DESCRIPTIVE REPORT  
(HYDROGRAPHIC)

Type of Survey ..... HYDROGRAPHIC .....  
Field No. .... HO-5-1-66 .....  
Office No..... H-8899 .....

State ..... Alaska .....  
General Locality ... Prince William Sound .....  
Locality ..... Vicinity of Valdez .....

HYDROGRAPHIC SURVEY REVIEW

VALDEZ, ALASKA  
VALDEZ STANDARD OIL DOCK

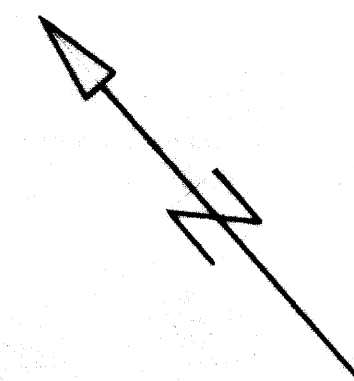
All data subject to verification  
and review by Washington office.  
*Data could not be verified inasmuch as field  
records for this tag line survey were  
not received in the Washington office.*
